Plan Commission

Agenda

Monday, January 27, 2020

SHEET
C1.2

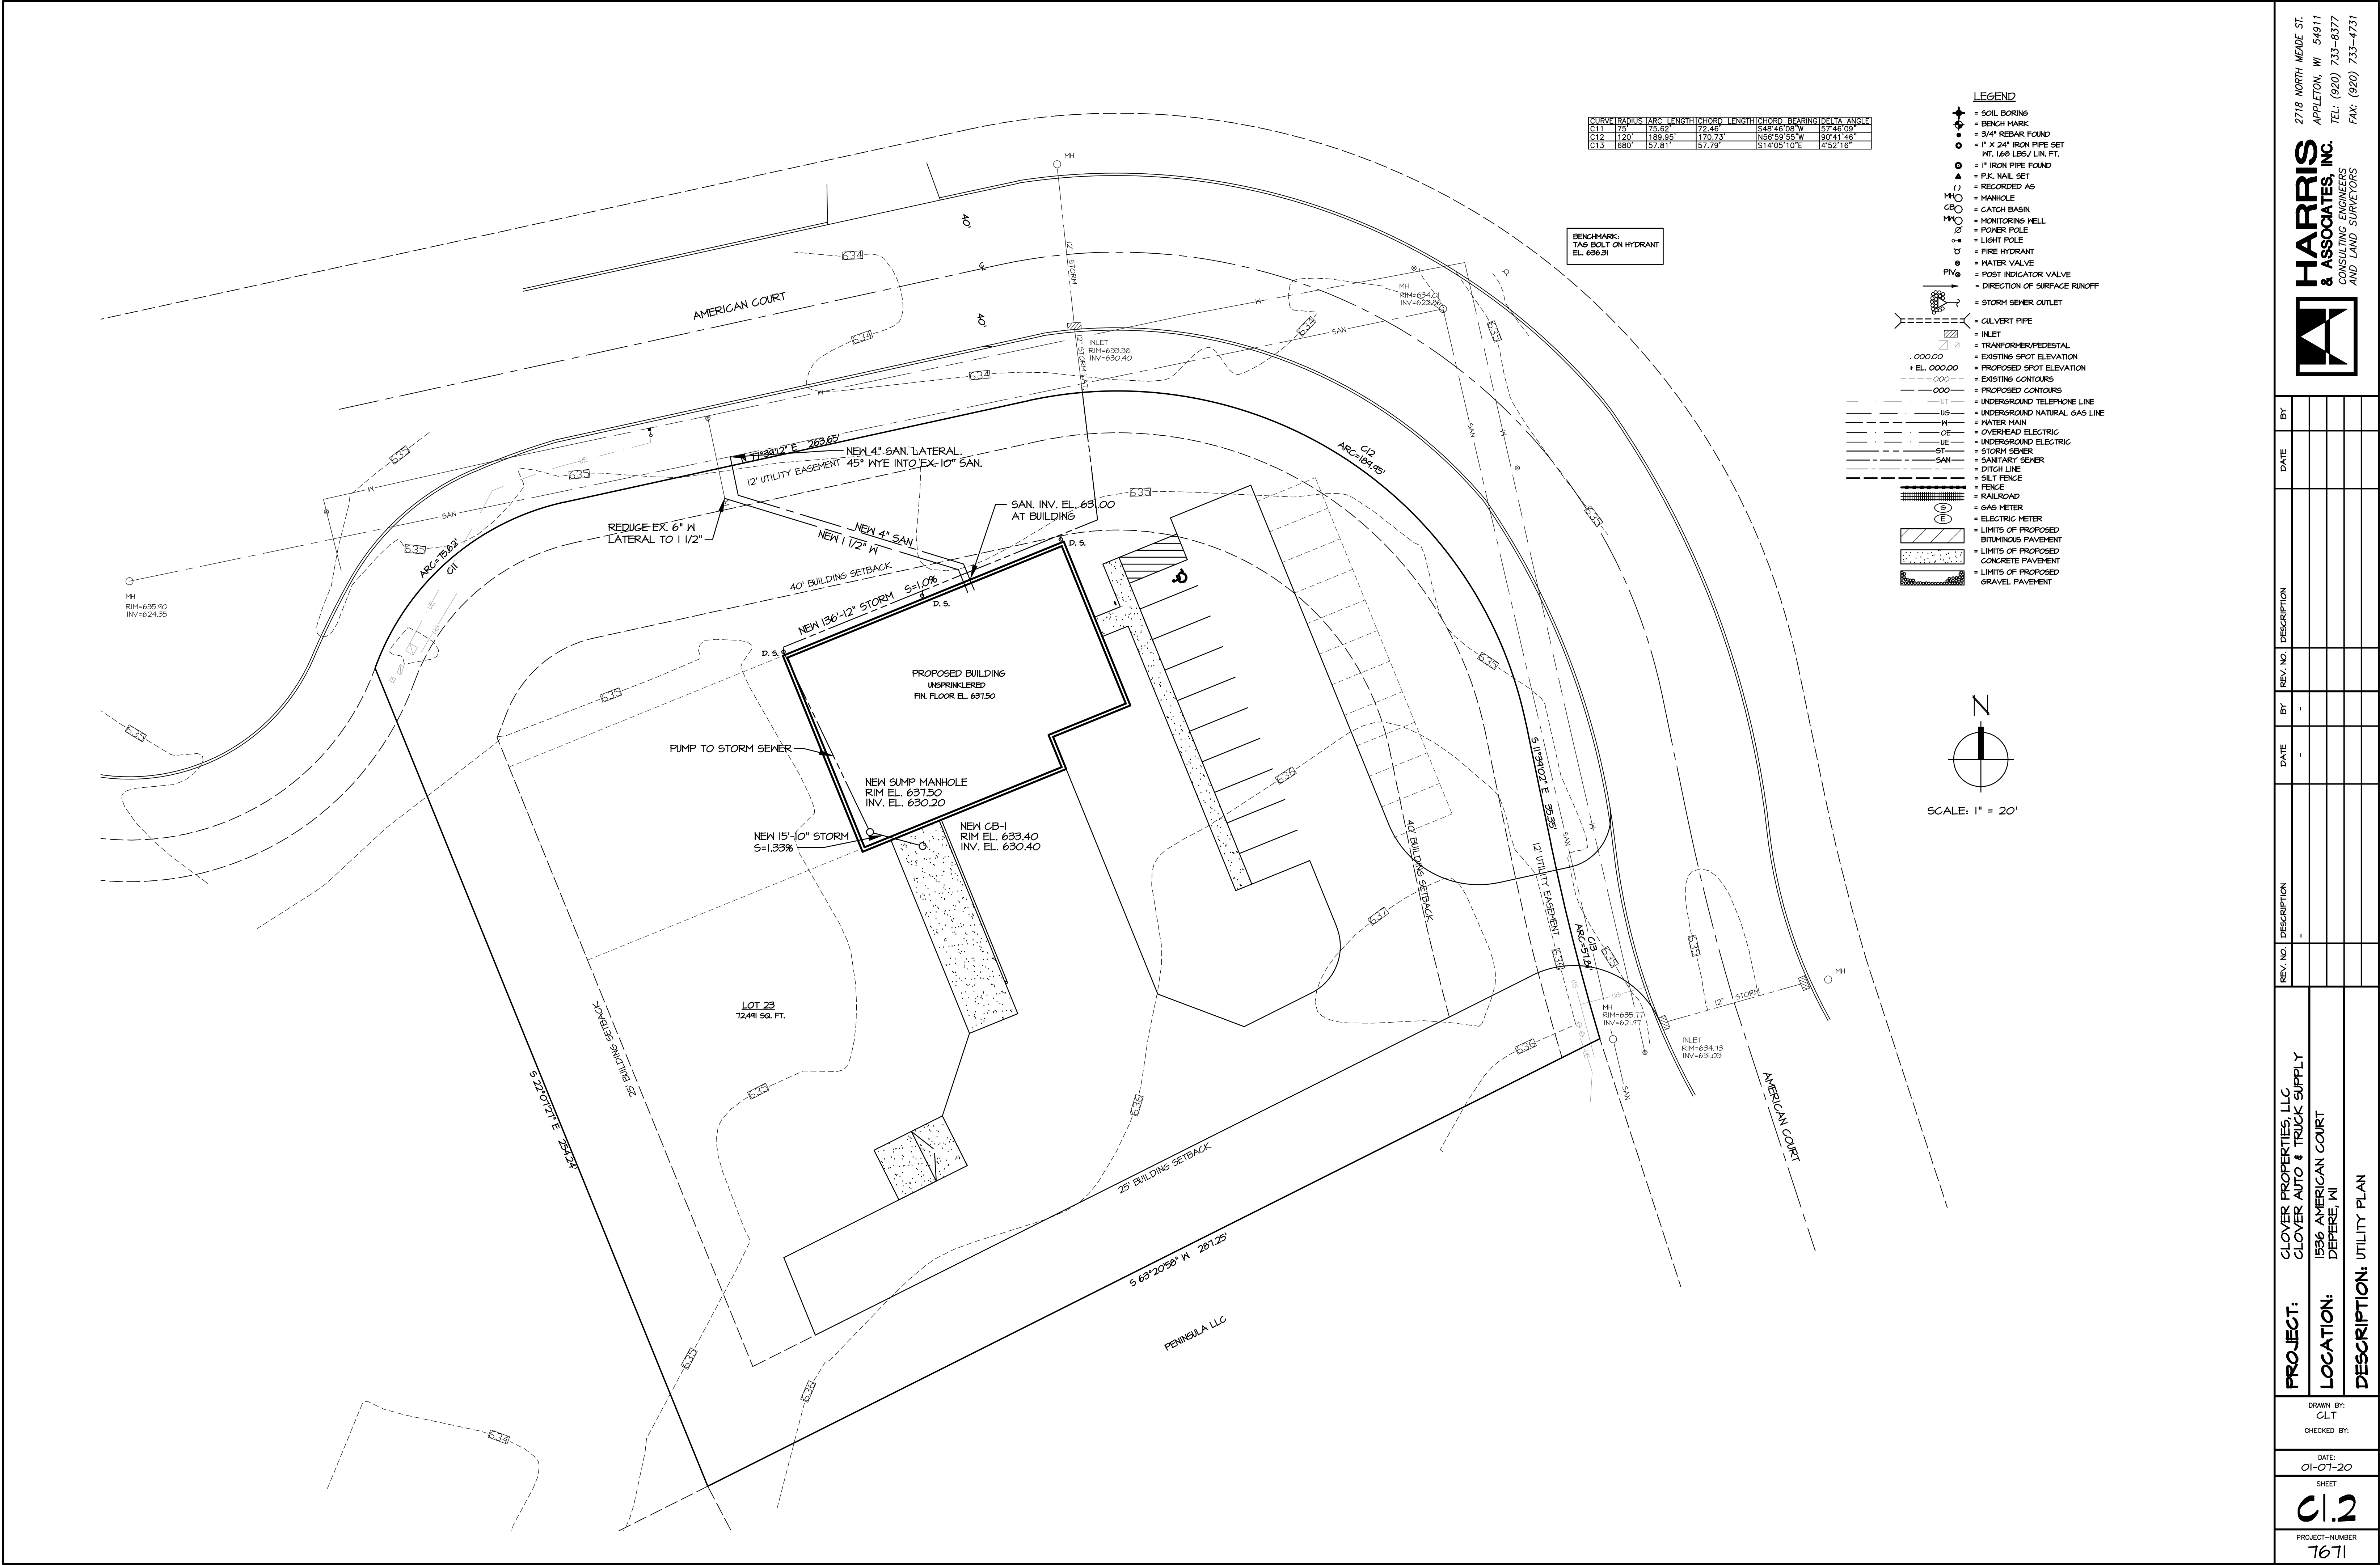
10. Sheet C1.2: The City's record drawings do not show a 6-inch water service for this property. A 6-inch water service is shown where drawn, but it goes across the road.

11. Sheet C1.2: The invert elevations drawn do not match those on the City's record drawings. The City's record drawings for American Court are available by request. There is a difference in elevation of approximately 0.3 to 0.9 feet.

12. Sheet C1.2: The City's record drawings show a 15-inch inlet lead across American Court and a 15-inch lateral stub out of the local inlet abutting this property. The rim elevation of the 15-inch lateral stub is 629.56.

13. Sheet C1.2: Please make note that an excavation permit is needed to dig down in the public right-of-way to make water and sanitary sewer connections. The excavation permit can be obtained with the City of De Pere Public Works at 920-339-4061. A minimum of two weeks is needed to review and process this permit.

14. Sheet C1.2: Make a note to contact the Water Department at 920-339-4063 a minimum of two weeks prior to tapping the water main so staff can be made available to inspect the water tap and work valves.

15. Sheet C1.2: Please specify the water meter size. Meters larger than 1-inch need to be special ordered and can take upwards of a month to obtain.
16. Sheet C1.2: Show all utilities in the right of way.
